# Customer Service Bulletin

<b>Product:</b>	Welch Allyn® Connex® Vital Signs Monitor 6000 Series™ Welch Allyn® Connex® Integrated Wall System Welch Allyn® Connex® Spot Monitor Welch Allyn® Spot Vital Signs® 4400 Device		
<b>Subject:</b>	SureTemp Plus Board Update		
<b>HW Version(s) Affected:</b>	P3,P5,P6 *CSM HW levels *4400 HW levels	<b>SW Version(s) Affected:</b>	N/A
<b>Serial Numbers Affected:</b>	N/A	<b>Lot or Date Code Affected:</b>	N/A

Figure 1 - WAST 1.10.0 SureTemp Test

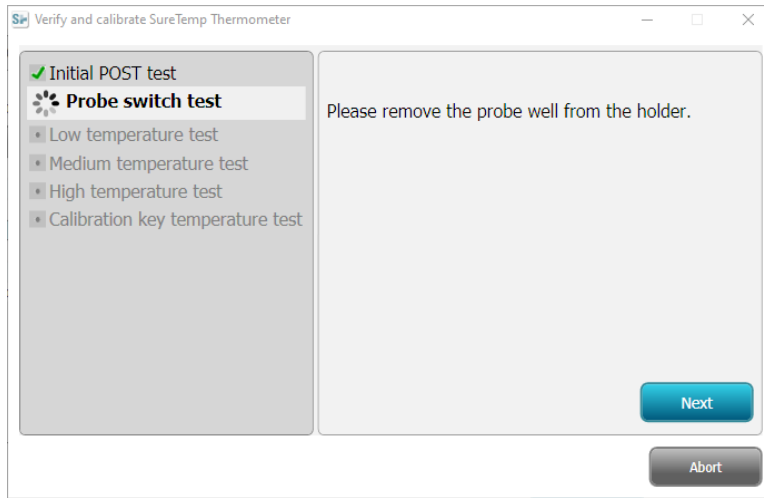
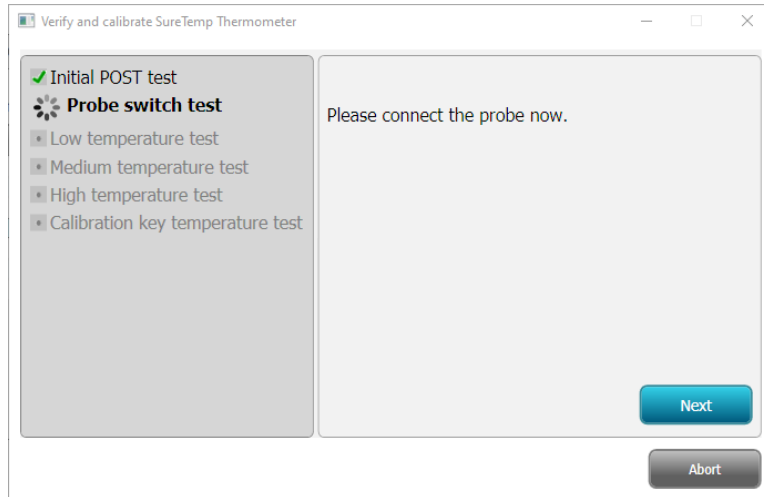
Changes for this version are within the Verify and calibrate tab the following instruction has been removed for the SureTemp thermometer (as seen in previous versions)—

Now the verify test jumps directly to reconnecting the temperature probe—
